TO: Fisher, Collins, & Carter, INC.  
RE: 1680 Woodstock Road

There were issues out in the field during the installation of your engineered OSDS plan. The following comments should be addressed for a redline revision.

**SEPTIC INSTALL PLAN**  
**1680 WOODSTOCK ROAD**

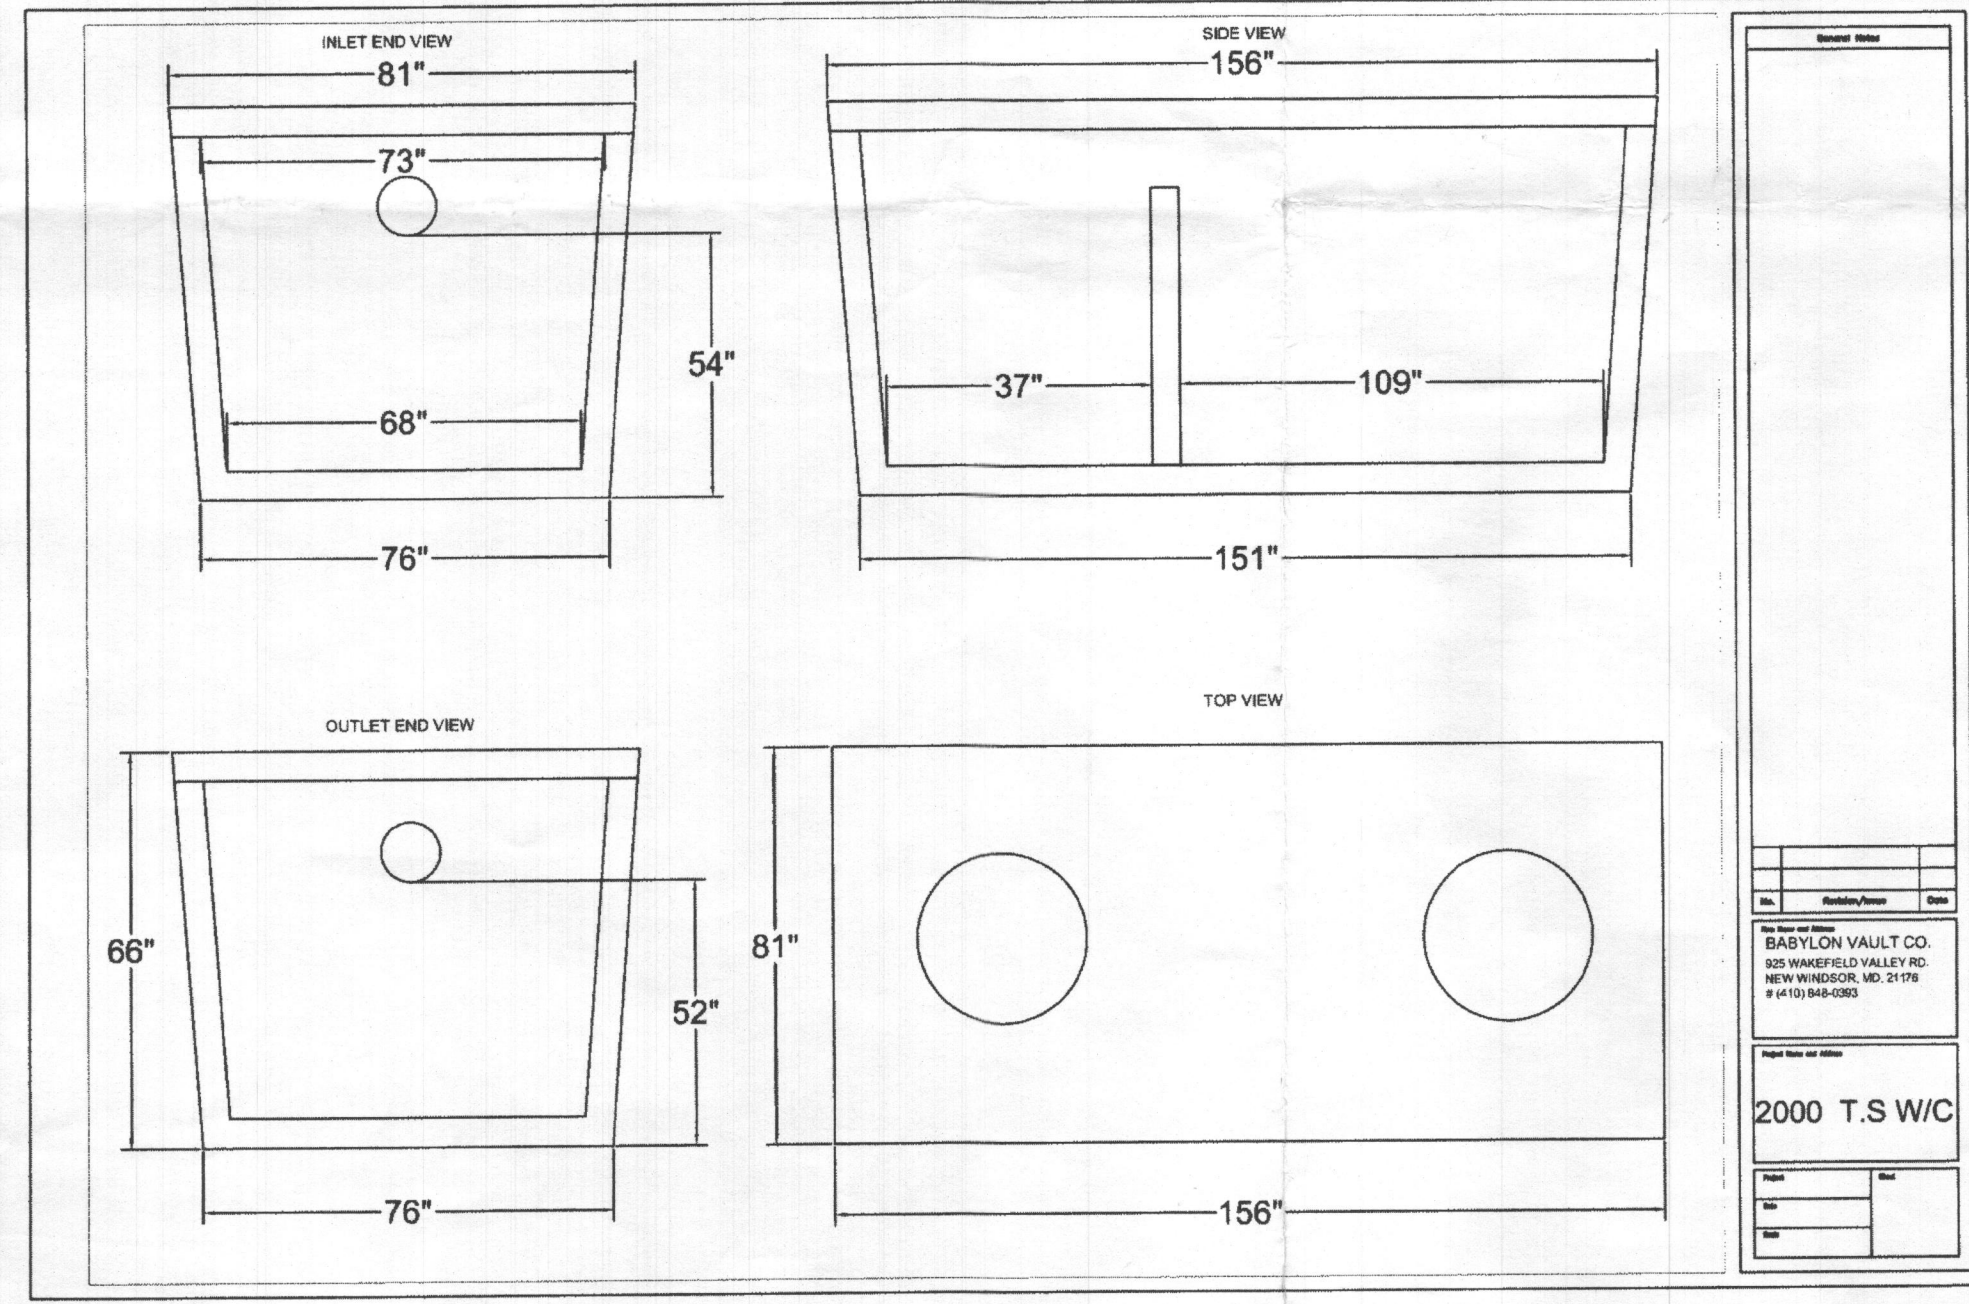
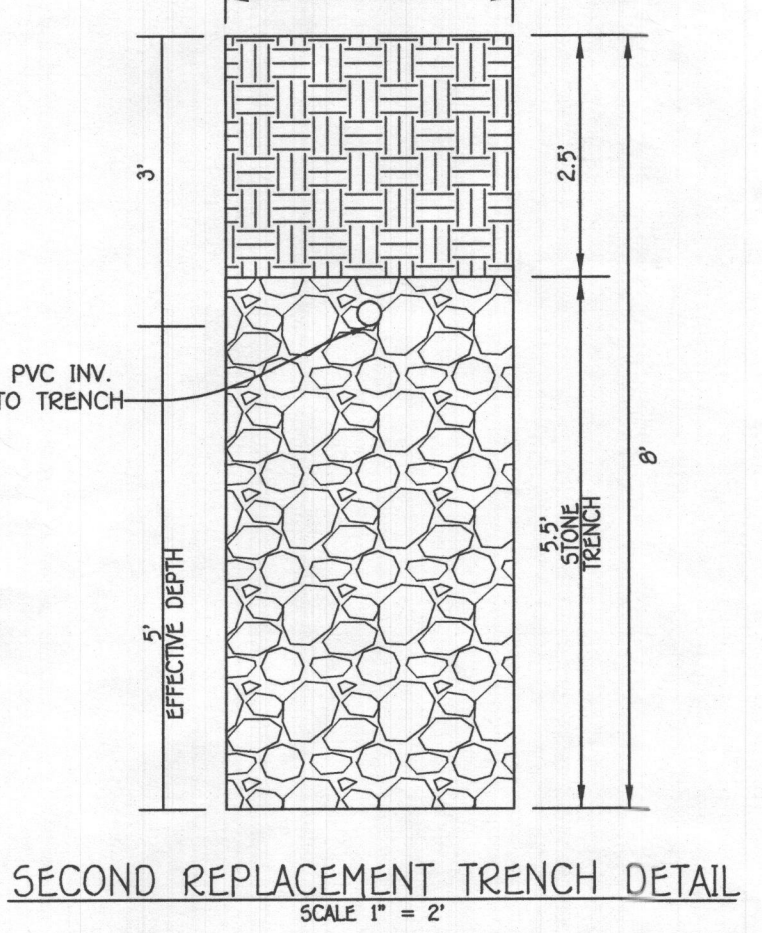
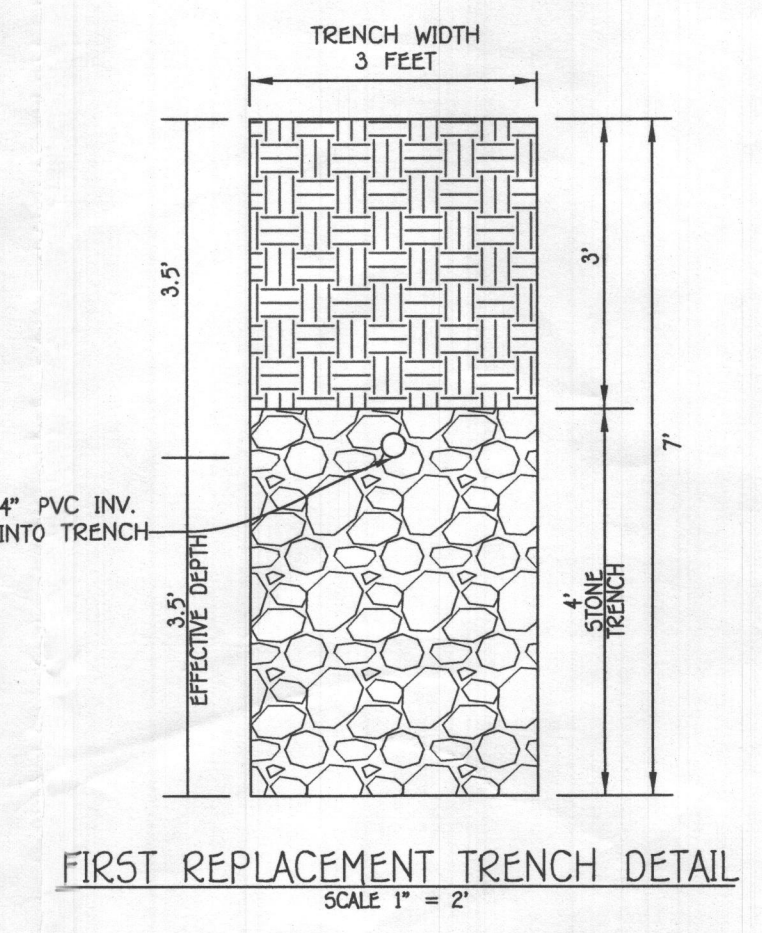
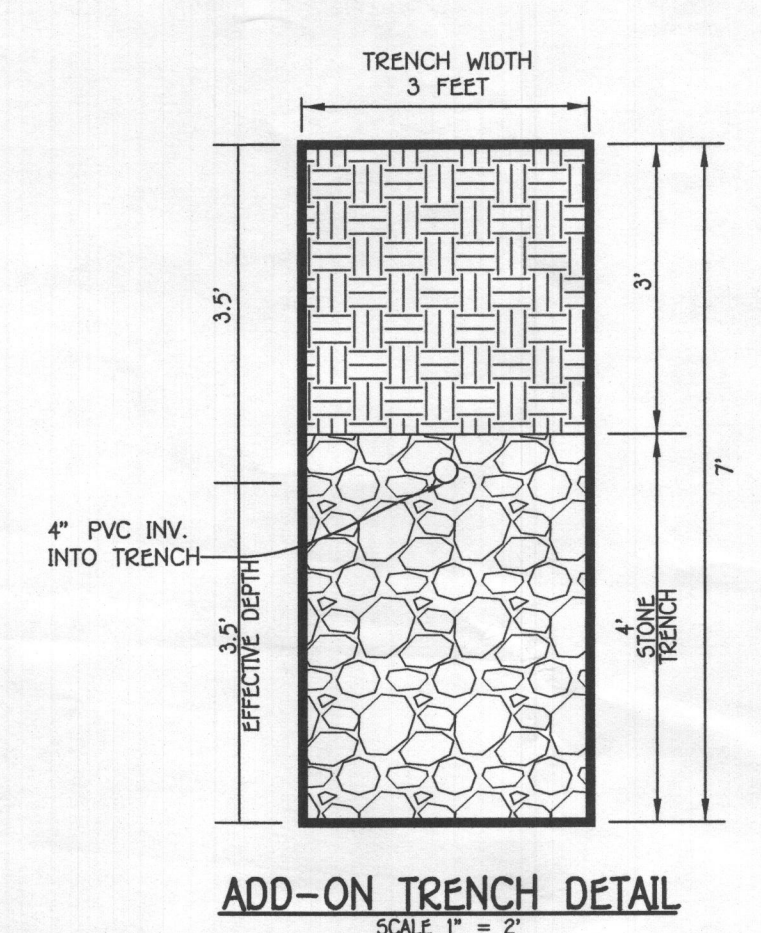
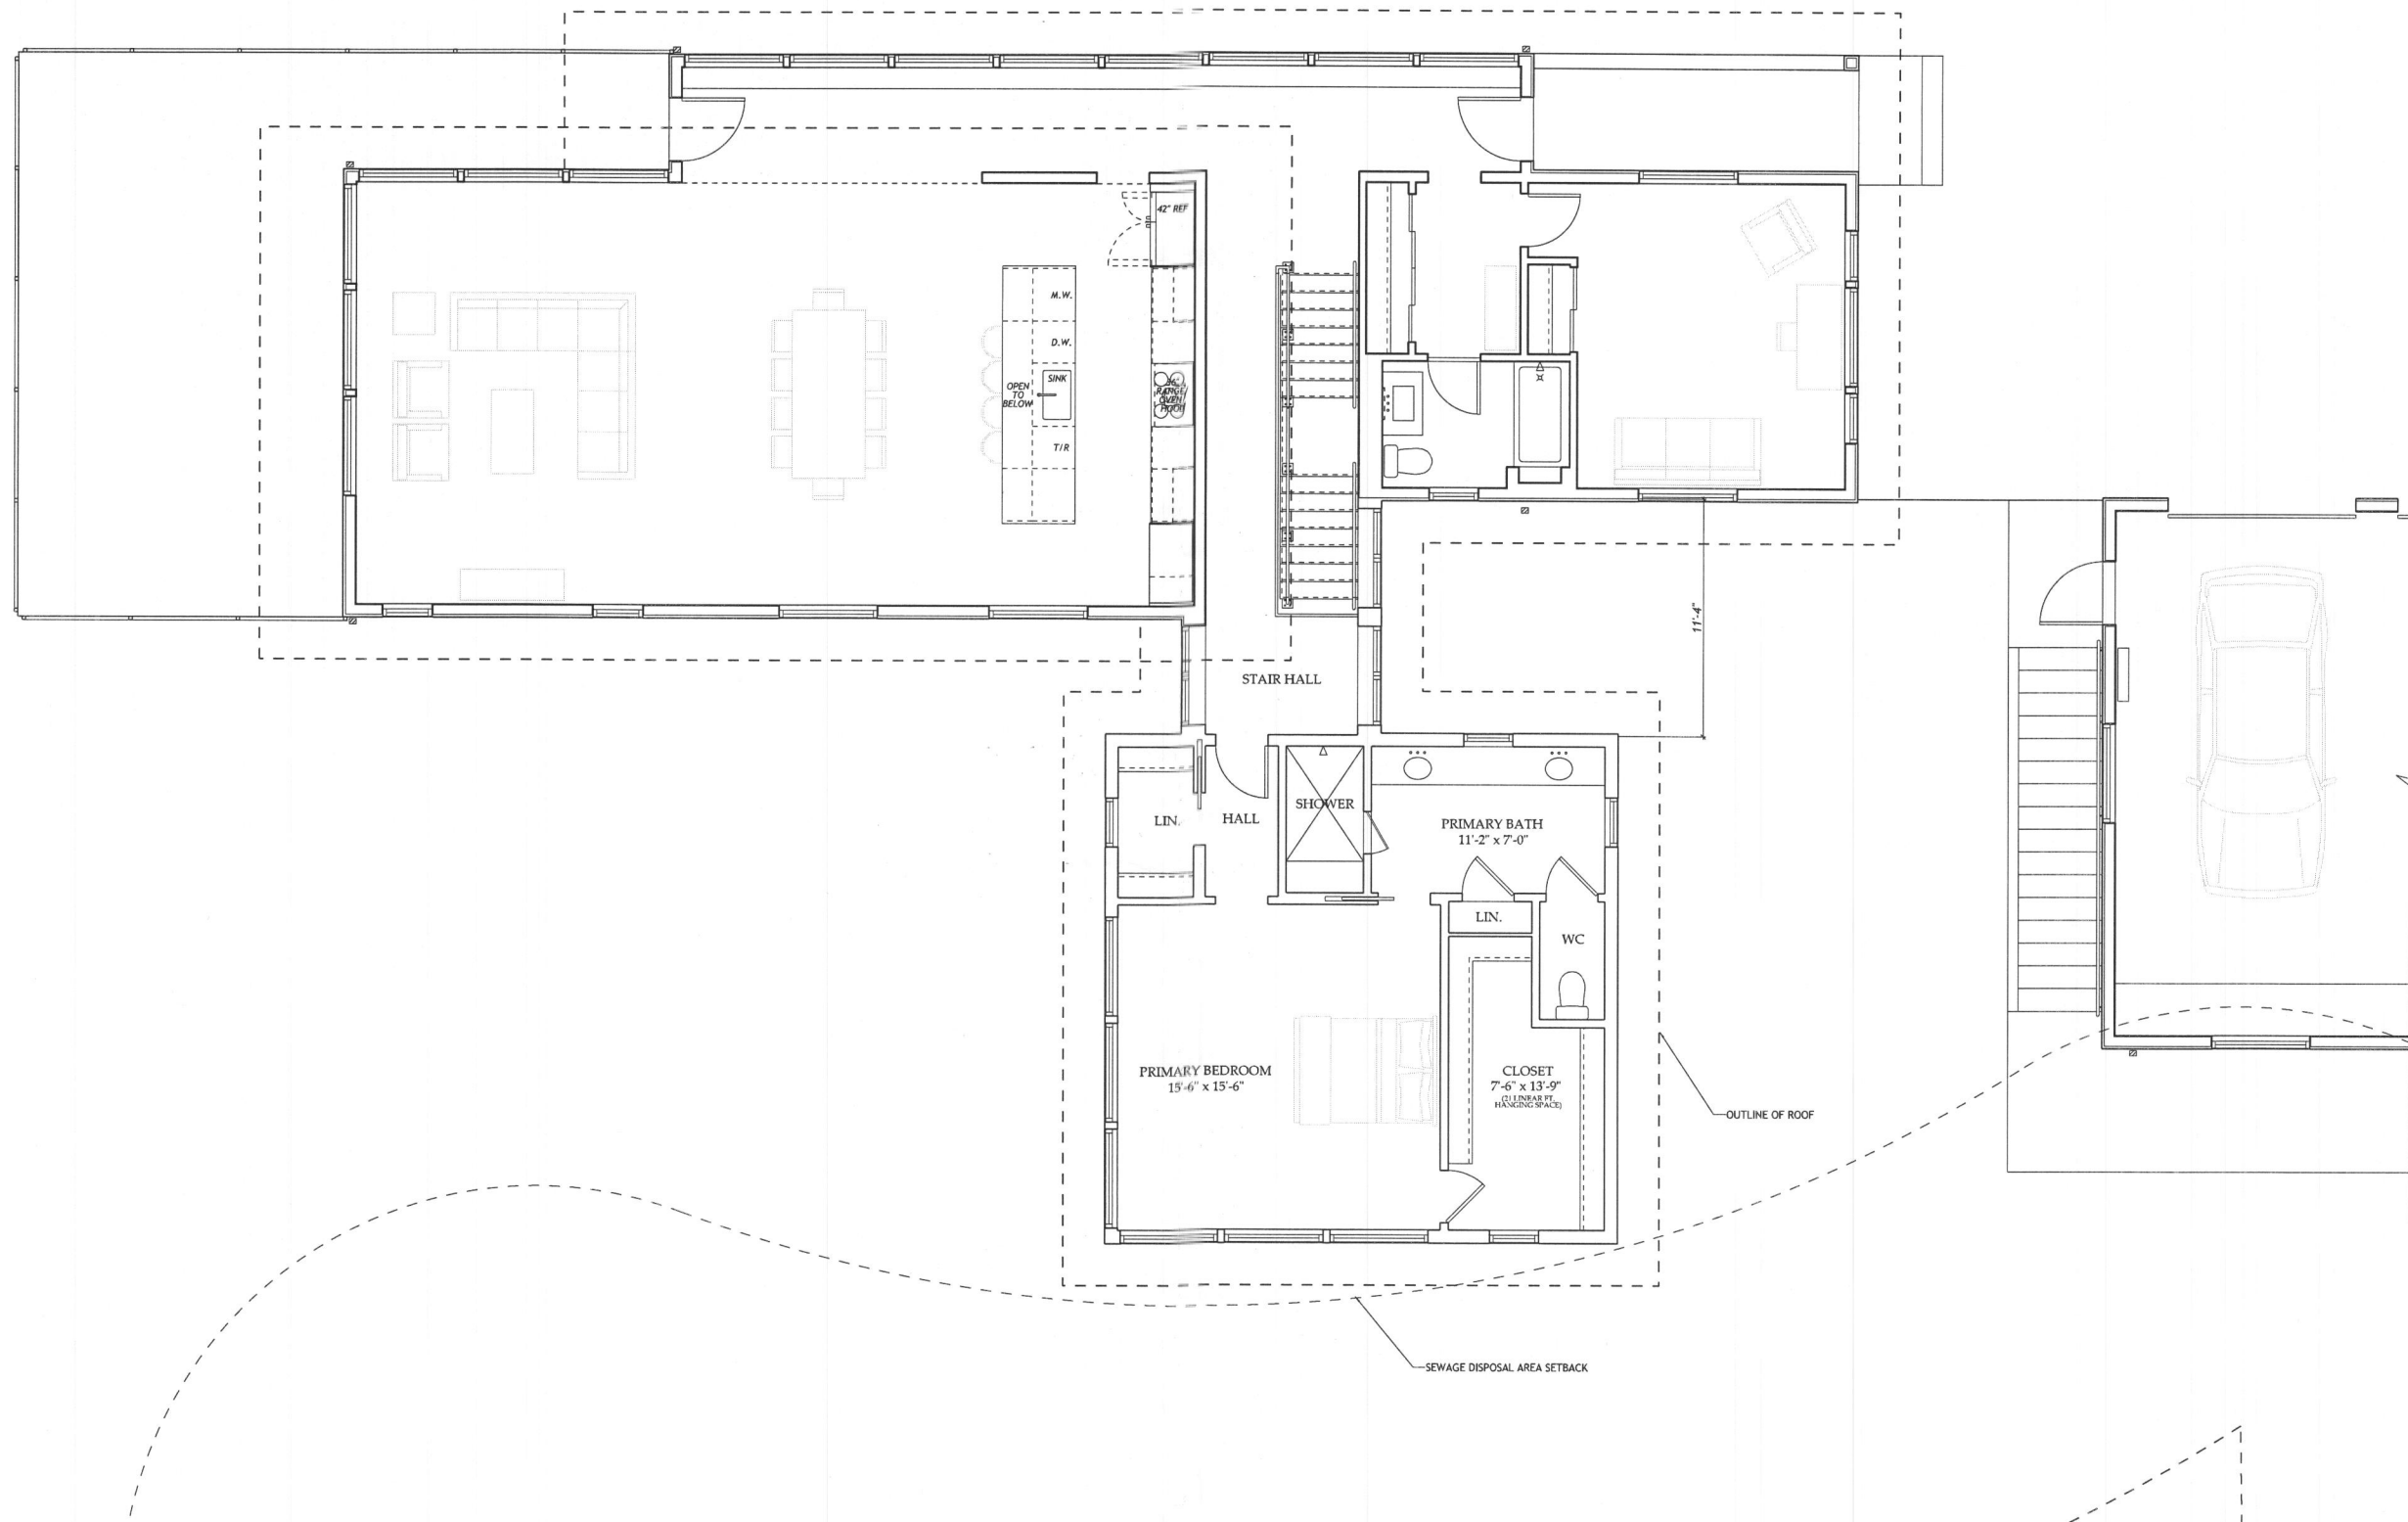
1. There are two options to try & resolve the lack of access to install a 2000 GAL concrete tank in the backyard.
  - A. Install two 1000 GAL Poly-Ethelene tanks in succession. Or one 1850 GAL Poly (if it exists).

1. Tank must be pre-approved by Howard County Health Department.
  - B. Design a path of construction via a non-evasive, and temporary "road" which will make bringing materials easier for all phases of project and possibly the 2000 GAL concrete tank.

- c. Consult with Fogles, hired septic contractor.
2. Since we last spoke, Ricky from Fogle's Septic believes that the only way to replace the tank may be by removing the old tank off-site, which should be noted as hazardous waste, and installing the new one at the old tank location.

- a. It may be possible to designate a new tank location, we were missing the septic profile to be able to determine this while out in the field.
  - b. Please consult with Fogle's.

3. Missing tank & septic profile showing all necessary elevations (I missed this on the previously approved plans.)
4. The main septic line from house to tank, cannot be shown how it currently is drawn.

- a. The addition construction will surely have a negative impact on its functionality.
  - b. Consult architect.
5. Add a reference point to the beginning of add-on trench that the hired septic contractor will do some slight grading to deter negative swale impact on existing SDA.

6. Need to add newly chosen tank details to septic plan, if applicable.
